# Brown Creek Tributaries Restoration Project Final Year 5 Monitoring Report

DMS Project ID No. 95351, DEQ Contract No. 004641

**Subject:** Response to DMS Comments for Task 11 Deliverables: Year 5 Monitoring Report  
Brown Creek Tributaries Restoration Project, Anson County, North Carolina  
Yadkin River Basin – CU# 03040104, DEQ Contract No. 004641, USACE AID SAW-2012-01108,  
DMS Project #95351

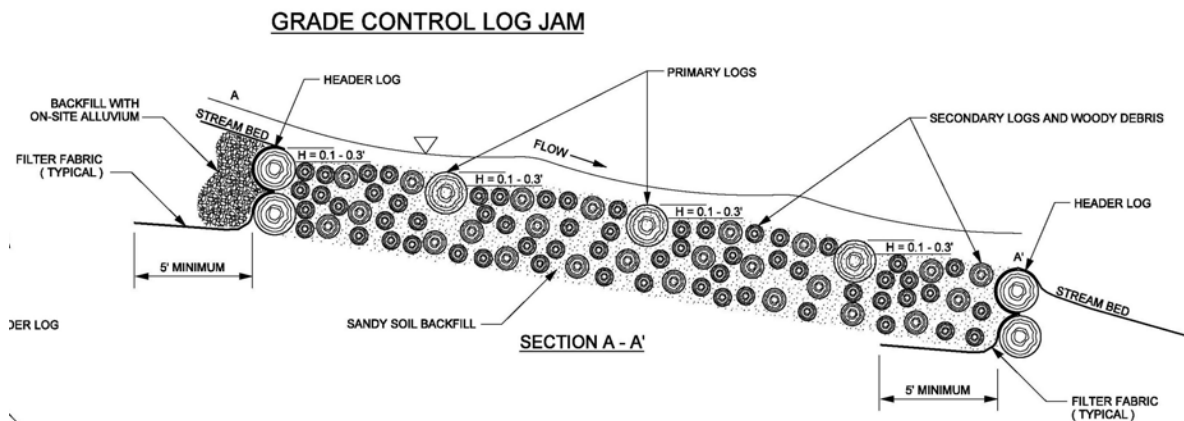
-The crossing gates between R4A and R4B and Hurricane Creek have been left open leaving evidence of direct cattle impacts during recent site visits. Please rectify this issue with the landowner.

**Response:** Baker had not previously seen or observed any evidence that the gates on Hurricane Creek had been opened in several years, with tall weeds growing within the rock crossing. The original landowner for this parcel passed away last year and his son (who owns parcels on the UT4 section of the project, but which don't have gated crossings) has taken over the property. After a recent inspection of the gates on site, we found that one has a damaged hinge and will be repaired as soon as possible, and we will talk with the current landowner about the issue. Of note, we found no evidence that cattle had ventured into the actual conservation easement itself, just within the crossing. No hoofprints, manure, or damage of any sort was observed.
